主旨: Re: [Departmental Comments] S. 16 Planning Application no. A/NE-LT/783 – Temporary Private Vehicle Park (Private Cars Only) for a

Period of 3 Years at Lots 1036 S.A, 1156, 1157 S.A, 1168 S.A and

1169 S.A in D.D. 19, Lam Tsuen San Tsuen, Tai Po, NT

# SITE PLAN (SCALE 1:650)

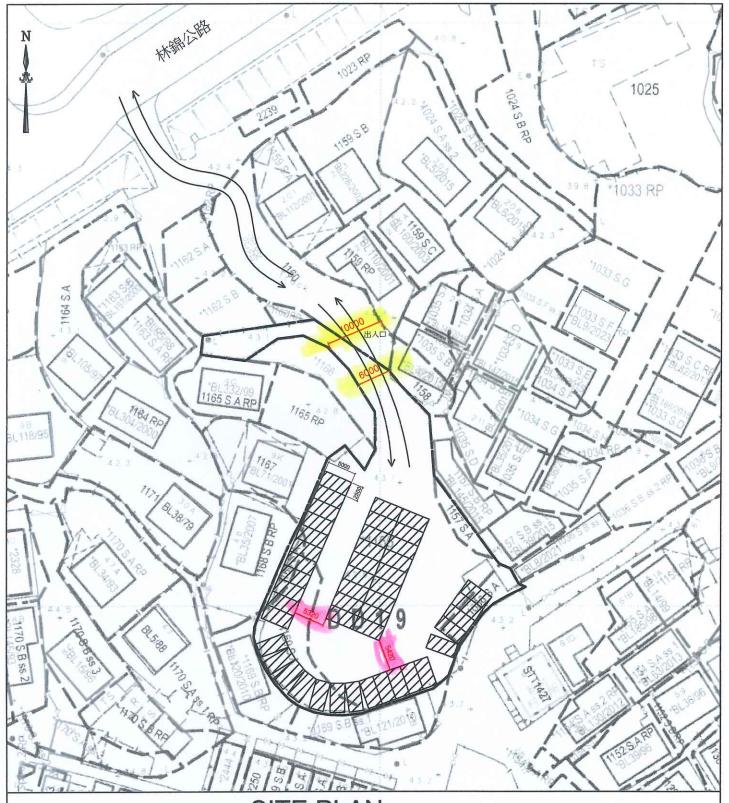
(i.) the width of access and aisles at the car park;

(ii.) demonstrate the swept path for the parking spaces outside house no. 48B

The minimum width (6m) and maximum width (10m) of the access and aisles have been (highlighted in yellow) on the plan.

The distance between the parking space and the middle aisle is 5.42m (highlighted in pink on the plan), which provides more than sufficient space. This parking layout has been in use for 15 years without any issues, and the configuration has remained unchanged during that time.
